FLEX-PLI-GTR Development

FLEX-PLI-TEG 5th meeting

Design review

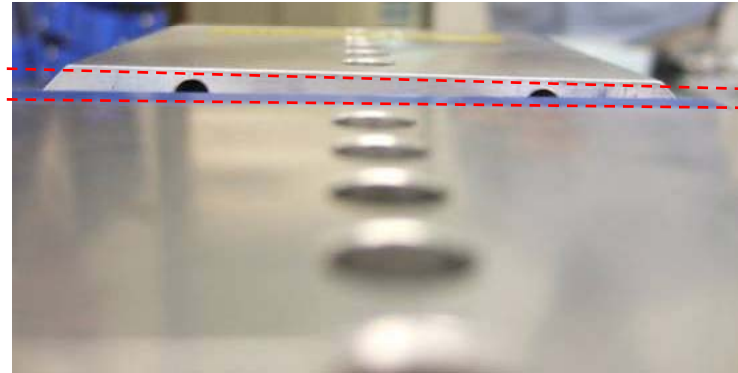
- Knee joint twist causes inaccuracy in ligament elongation measurements
- Cruciate ligaments exert a twist moment (z-axis along bone) between femur and tibia
- Correct angle is maintained by friction only
- Rotation between femur and tibia is likely to occur
 - Inaccurate ligament elongation measurement likely

Thigh (3-point bending)

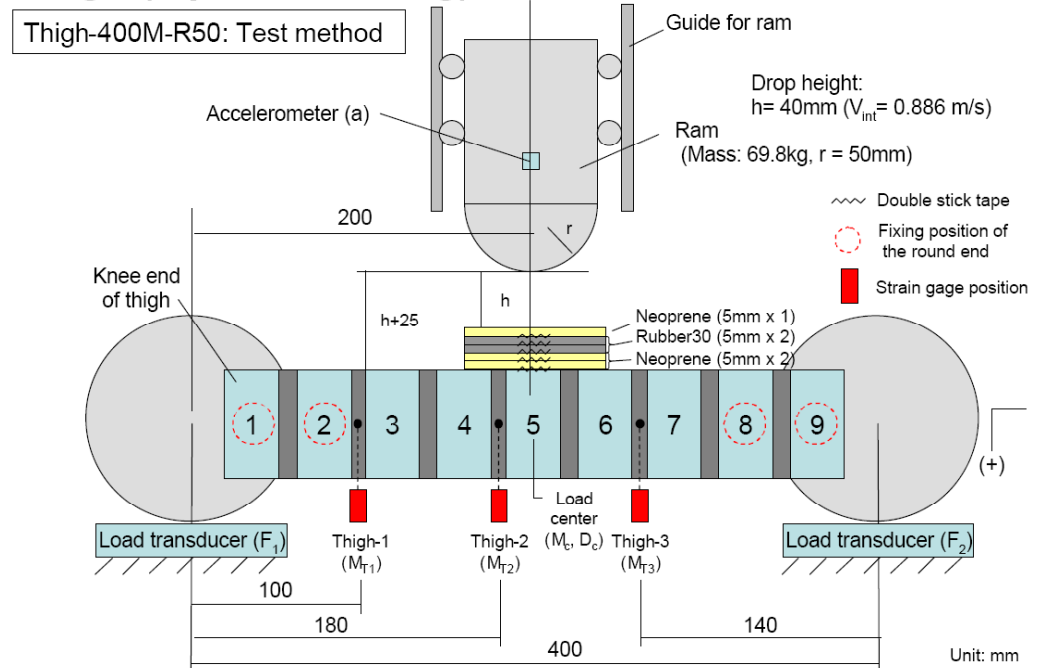
- Evaluate calibration method of bending moment strain gauges
- Dynamic test?
- Accuracy of position of strain gauges with respect to load transducers?
- Displacement of supports during bending?
- Tensile loading in z-axis?

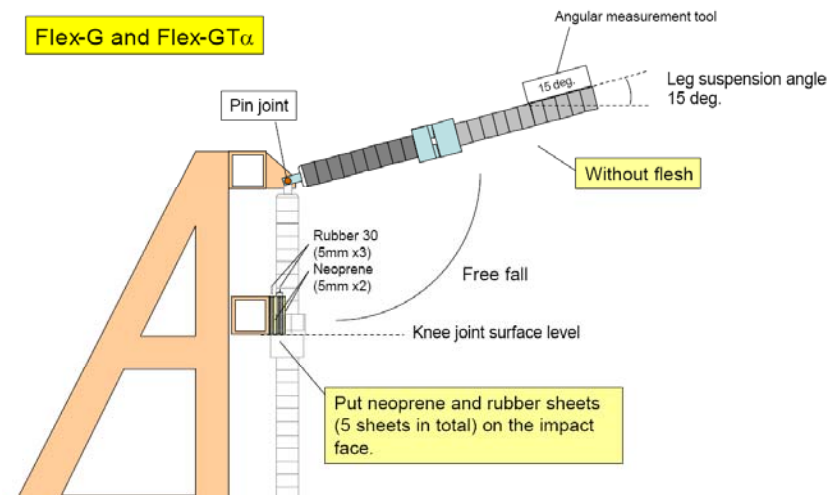
- Dynamic calibration method for control of dynamic response
- Impact pulse controlled by neoprene and rubber sheets
- Neoprene and rubber sheet material may deteriorate over time: not controlled
- No feedback on severity of impact pulse
- Test is not representative for the loading during vehicle tests

Durability issues:

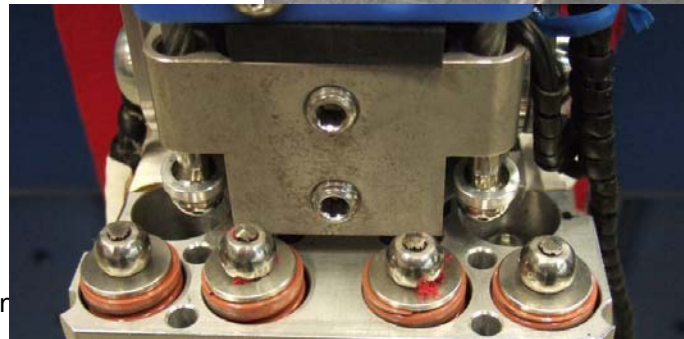
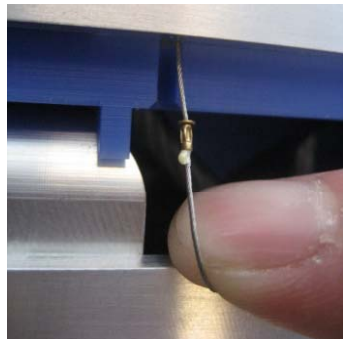
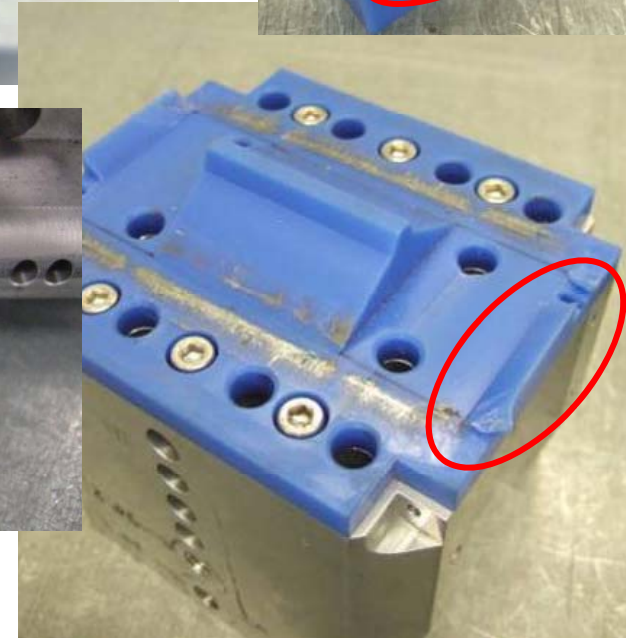
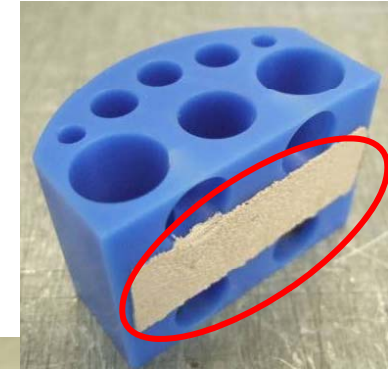
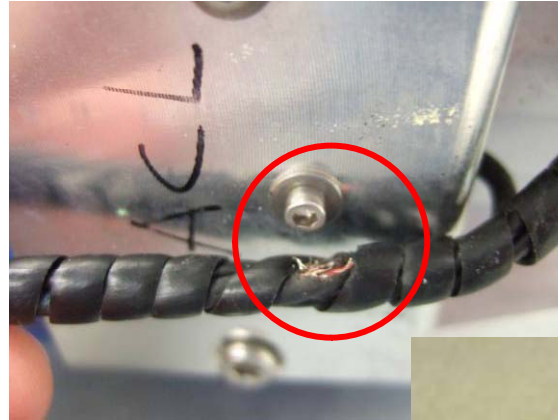
- Internal wiring
- Cable plastic sleeving
- Double side tape bonding
- Blue nylon liner damaged
- Innerside of neoprene skin sheets
- Stringpot stop

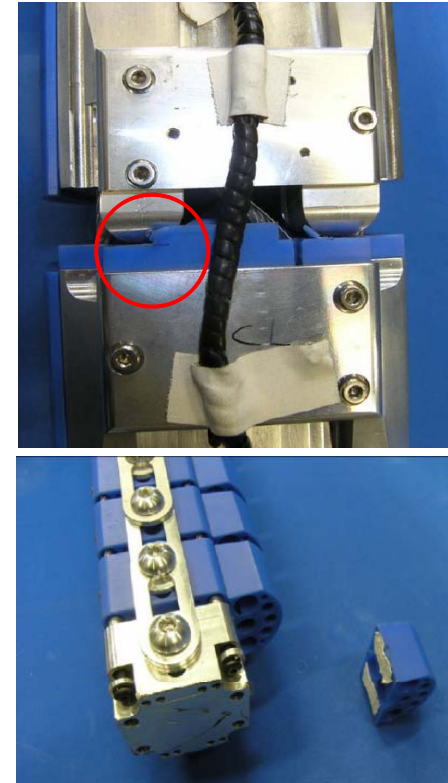
- Edged shape of the legform's impact surface seems to increase rotation around z-axis during impact: possible reason for scatter in ACL and PCL results
- **Cables likely to be damaged when the impactor falls on them**
- Influence of cables on the flight behaviour
- Cable guiding with sharp angles and around sharp edges, cables likely to be damaged near the impactor
- Tibia surface plate damage
- Neoprene skin: Zippers very sensitive, skin gets caught in spring ends, skin damaged by sharp edges of knee
- Separation of lowest segment impact face

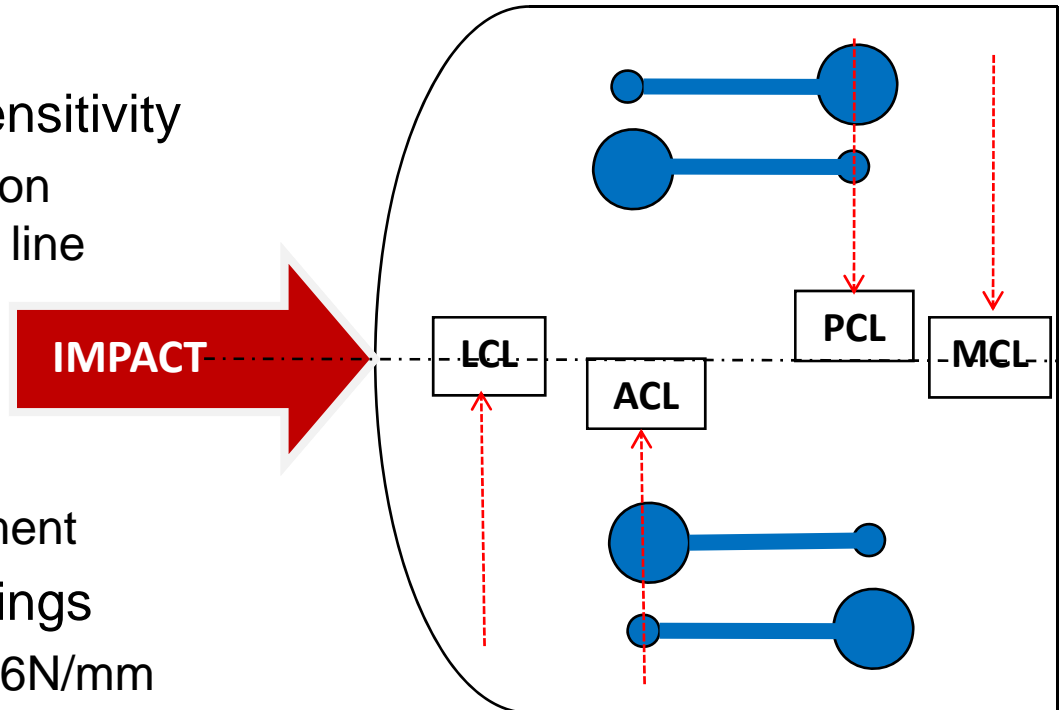
- To avoid A-symmetric sensitivity
 - Move ligament elongation measurement to centre line
- To avoid knee twist
 - Use two sets of cruciate ligaments
 - To neutralize twist moment
- Cruciate ligaments 8 springs
 - DBØ12xØ6x40mm; 71.6N/mm
 - May need to go Ø3mm cable
 - Optimized space for DAS & connector
- Lateral ligaments 16 springs same
 - DBØ18xØ9x80mm; 76.7N/mm
